Product / Process Change Notification

N° 2020-059-A

Implementation of matrix leadframe for Package PG-TO252-3 in Tongfu Microelectronics Co., Ltd. (TFME)

Customer Information Package 3_cip20059_a

Package Outer Dimensions

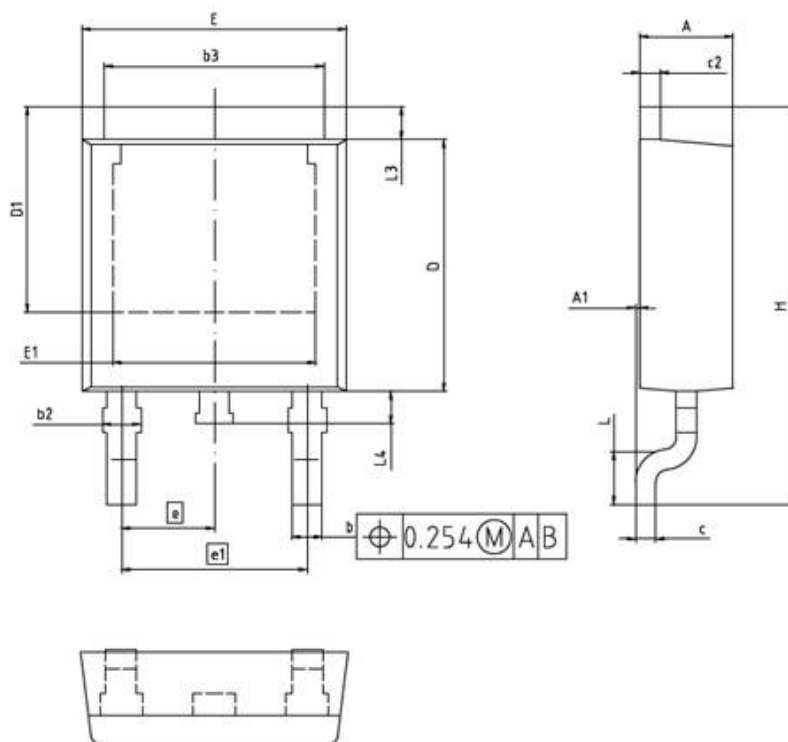
- > All package outer dimension are within the existing Infineon datasheet drawing with the exception of E1. (E1 updated from 5.21mm to 5.50 mm)
- > There is no impact in footprint, product quality, performance and reliability as verified by qualification.

TFME TO252-3 single row leadframe

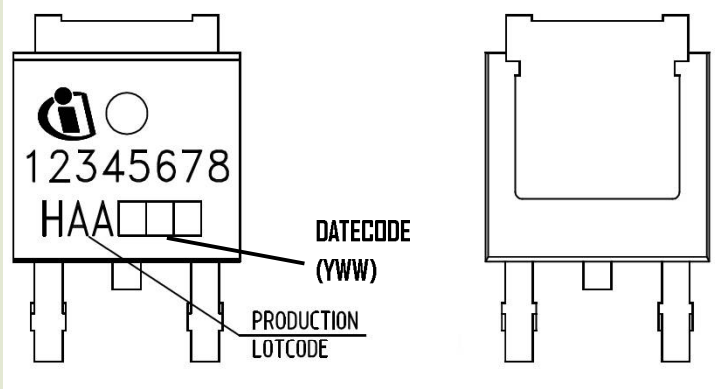
Visual Appearance for TFME TO252-3
